This document is received on The Town Planning Board will formally acknowledge the date of receipt of the application only upon receipt of all the required information and documents. APPLICATION FOR PERMISSION

For Official Use Only 請勿填寫此欄	Application No. 申請編號	A/TP/693
	Date Received 收到日期	A second the problem of the second se

Drainage Project Division of Drainage Services Department The Government of the Hong Kong Special Administration Region 香港特別行政區政府渠務署排水工程部

AECOM Asia Company Limited

FIGURE 3,2,5

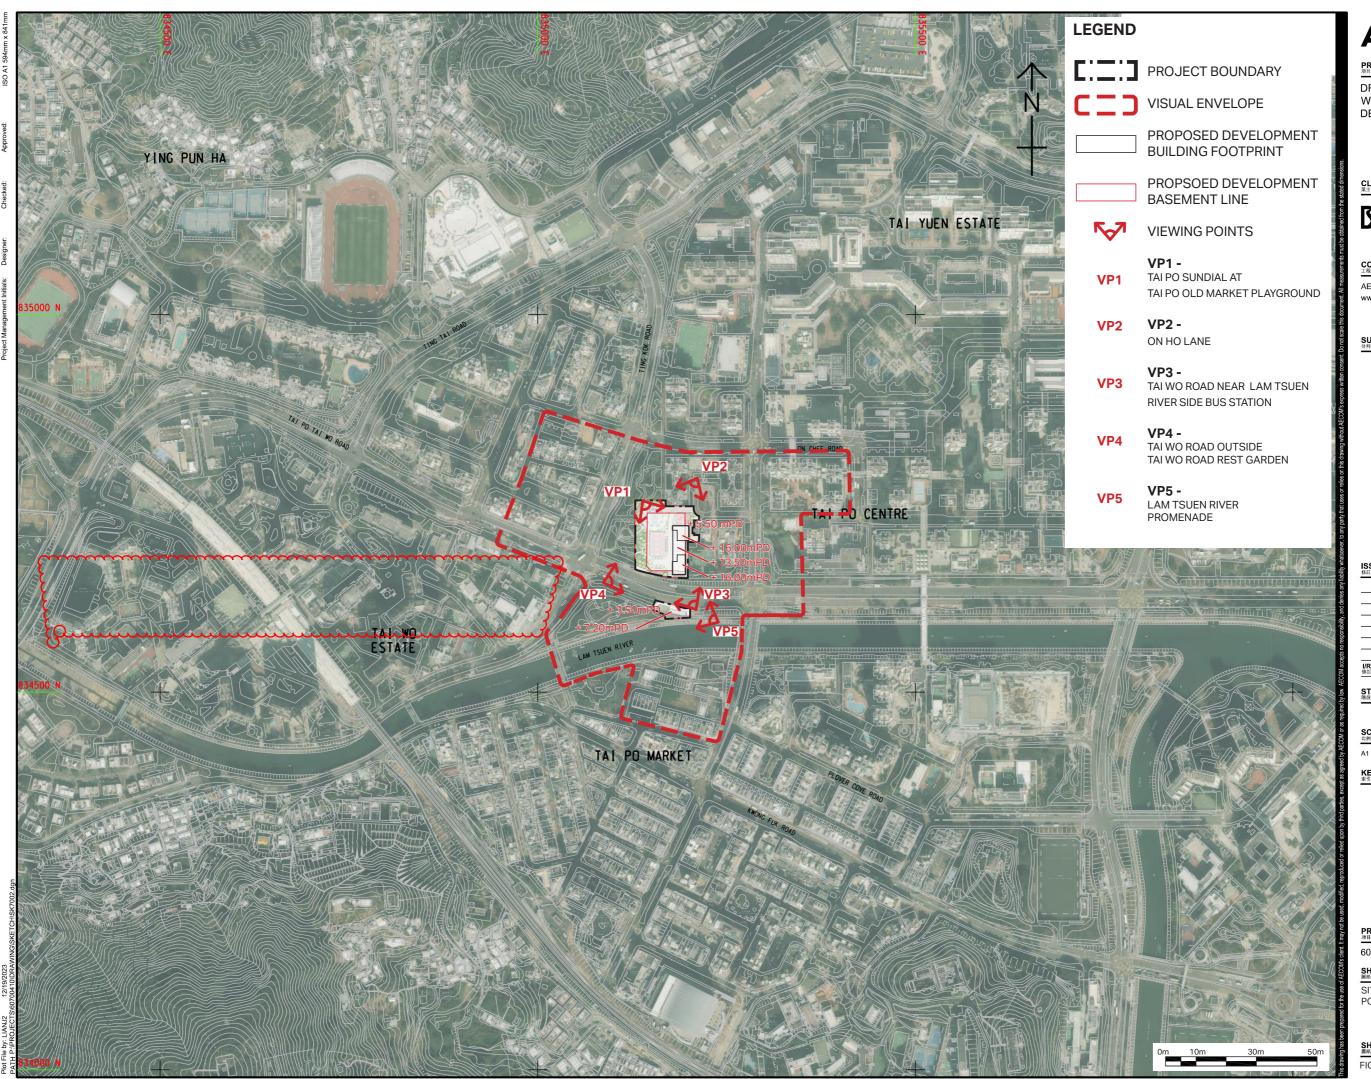
<u>ltem</u>	<u>Comments</u>	<u>Responses</u>
	ii. It is observed that the location of proposed VG in fig. 3.1.2, 3.2.2 and 3.2.3 is different from the VG location as indicated in fig. 3.2.1 and 3.2.5. The applicant should review all drawings and ensure consistency.	Noted with thanks. Figure 3.2.1 and 3.2.5 has been updated.
	iii. RtC item 13:- It is acknowledged that T329 is unavoidably affected by required works area for temporary earth lateral support and excavation, and the feasibility of transplanting of the subject tree is low considering its condition and established root system. The applicant is advised that the justification for removing T329 under RtC should be reflected in the planning statement.	Noted. Justification for removing T329 has been added as Para. 4.2.6 in the Tree Preservation and Removal Proposal.
	iv. It is noted that about 60% of the compensatory trees are small trees species proposed for hedge planting. The applicant is encouraged to explore opportunity on off-site compensatory planting in proximity to the project site to achieve the compensatory planting ratio of 1:1 in terms of aggregated DBH as far as practicable. In situations where this compensatory planting criterion cannot be achieved, the difficulties should be demonstrated in the planning statement.	Please be clarified that the trees compensation and transplanting has achieved 1:1 compensation ratio in quantity on-site as required in Para. 1(v)(b)(1). Other compensatory planting site in proximity to the project site would be explored during construction stage.

9.	Appendix C Architectural Design, Figure 3.2.5	Amended extent of vertical greening Amended annotation for proposed underground storage tank
10.	Appendix C Architectural Design, Figure 3.2.7	Deleted white line in the centre of drawing
